MODIFICATION APPLICATION, PARKES SOLAR FARM

23 SEPTEMBER 2016

Project Number: 16-208

## **ATTACHMENT A: GENERAL LAYOUT OF DEVELOPMENT**

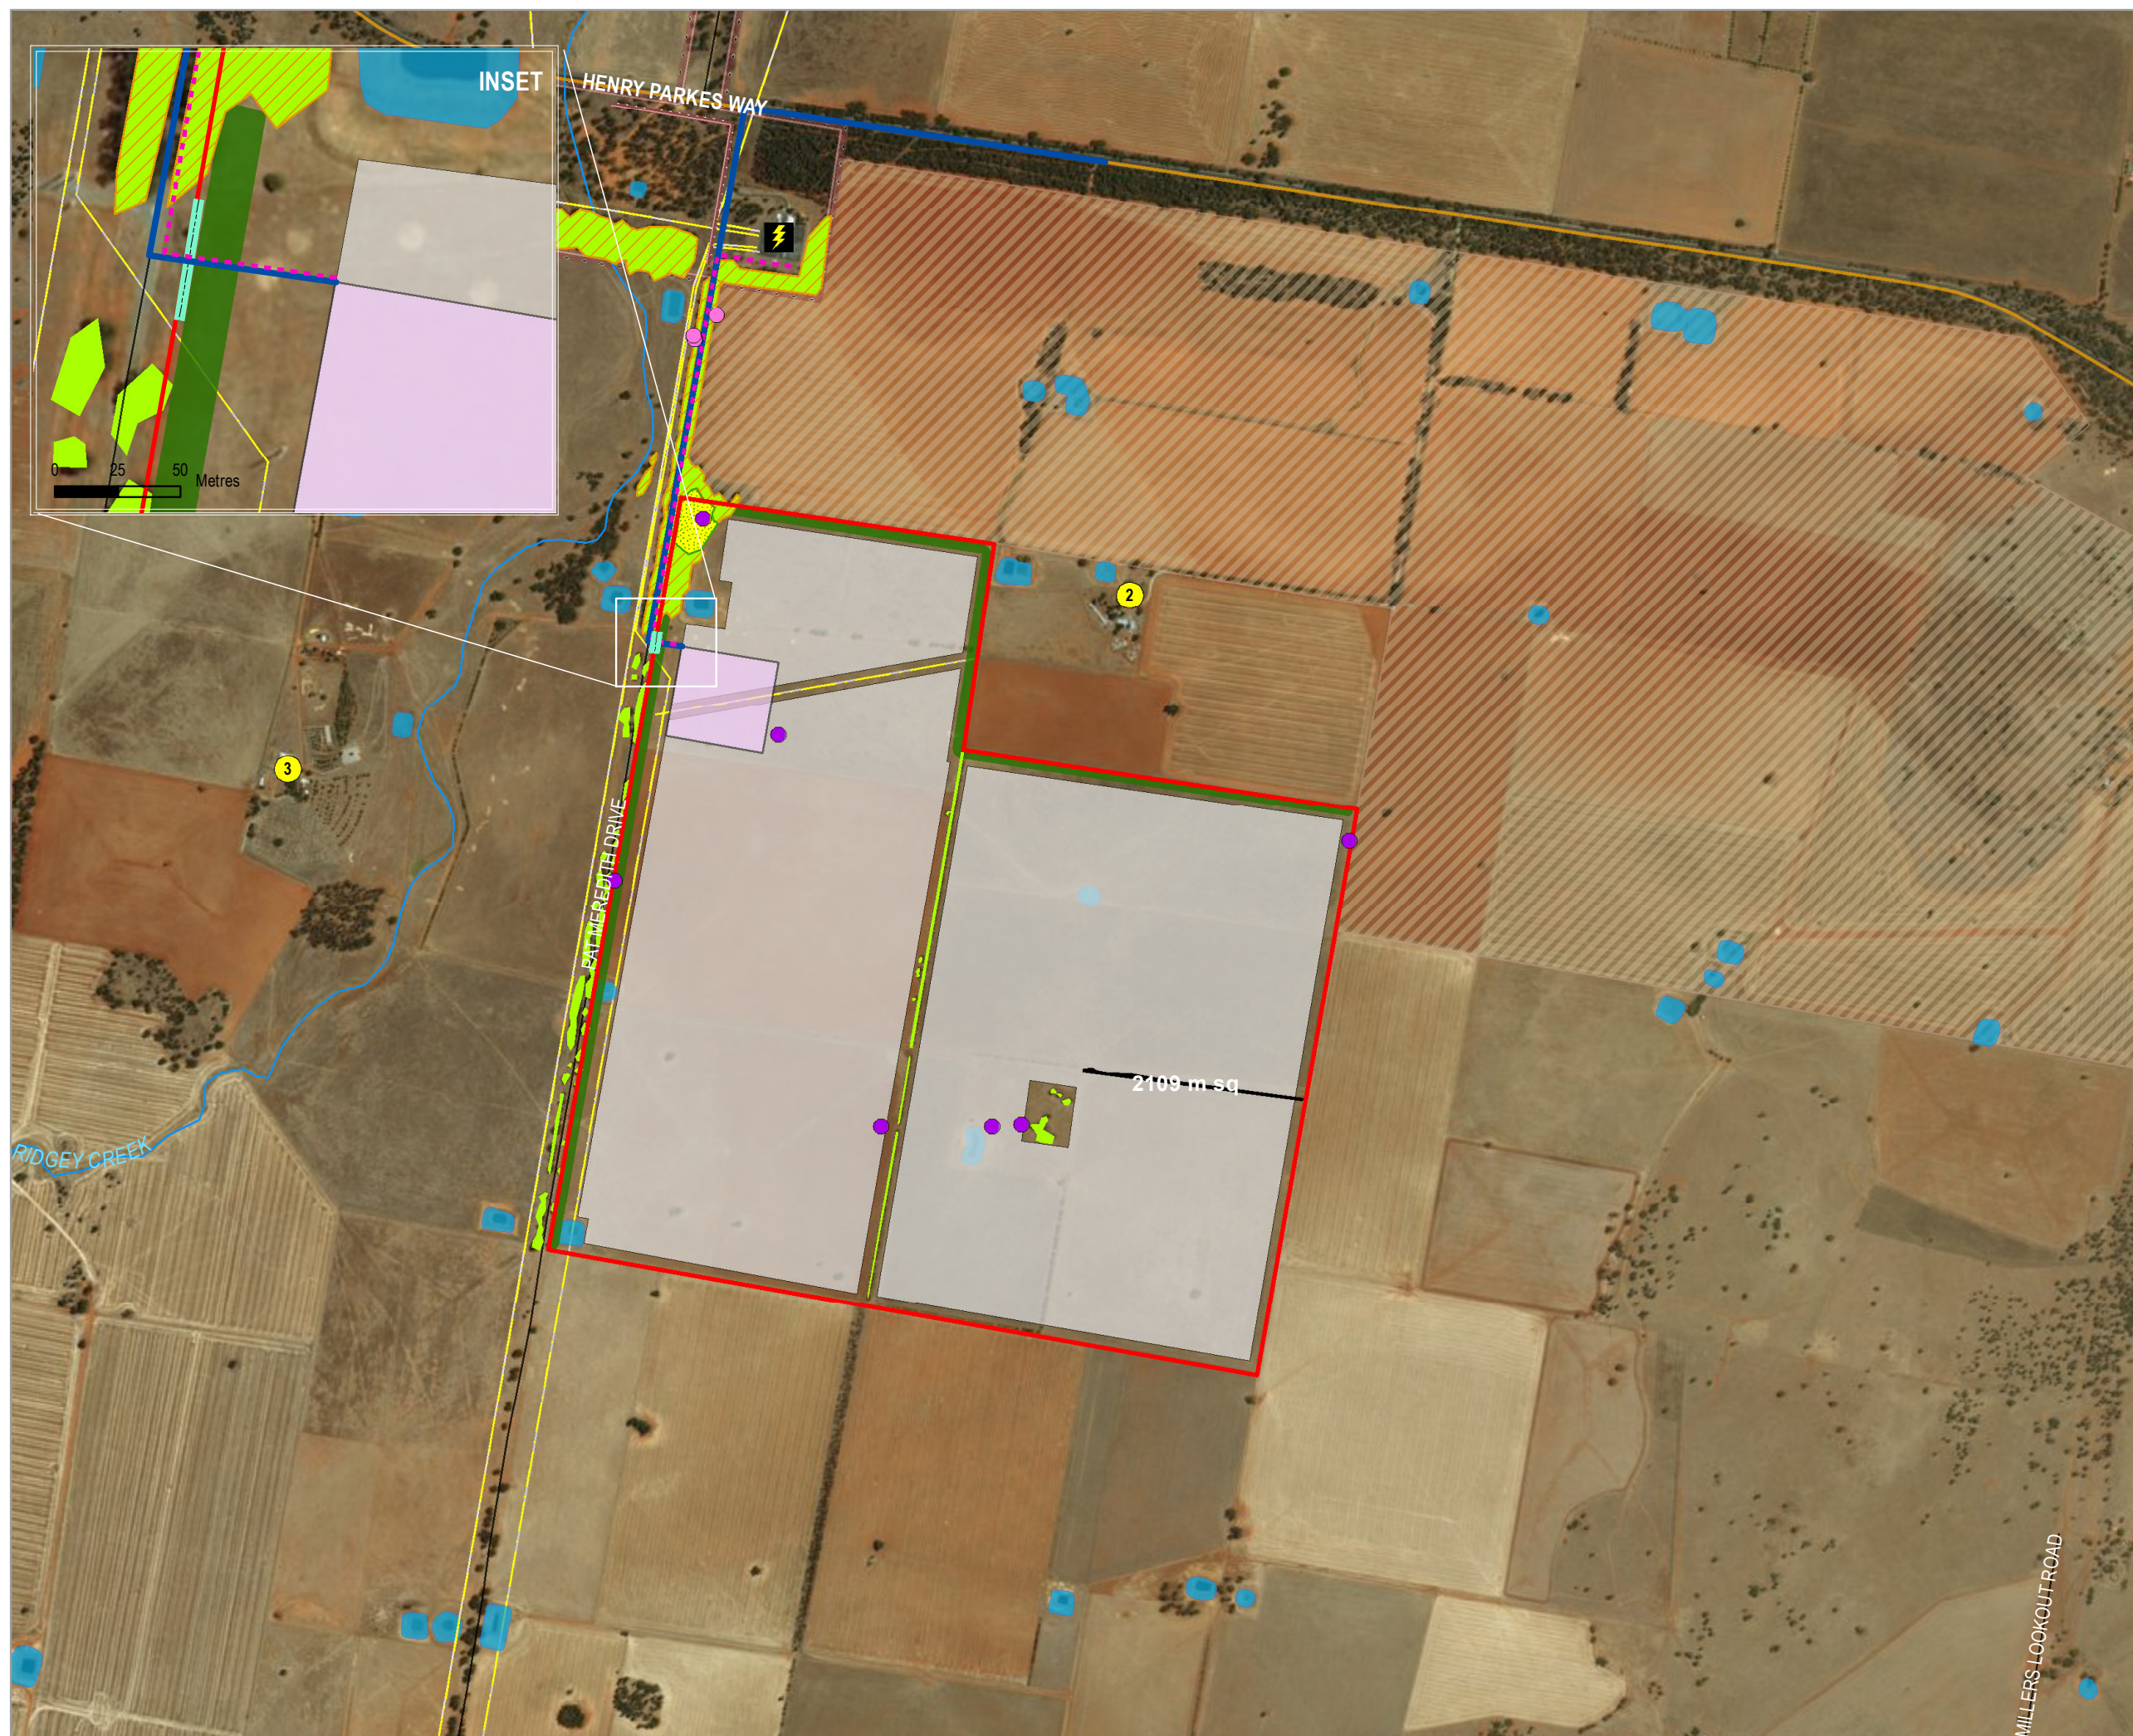
1. Site access from Pat Meredith Drive would be relocated to the south of the currently approved location by approximately 250 metres. This would result in;

- iii Facilitating relocation of the site carpark, operation and maintenance buildings
2. Relocation of the proposed laydown area, construction offices, site carpark, operation and maintenance buildings and substation to a location 250 metres south of the currently approved location. Relocation of site access to the south would;

3. Removal of the narrow east-west vegetated strip to allow for the expansion of the solar array into this area. This 2100 m<sup>2</sup> of vegetation, that consists of planted rows of trees, is highly disturbed with the native shrub and ground cover layer being mostly absent it conforms with the description of Grey Box Grassy Woodland EEC. Extending the solar array into this area will allow for a;

4. Revegetation of approximately 0.91 hectare of cleared farm land. The relocation of the laydown area, construction offices, site carpark, operation and maintenance building and substation has created an opportunity of planting out this cleared area which is surrounded by higher quality EEC.
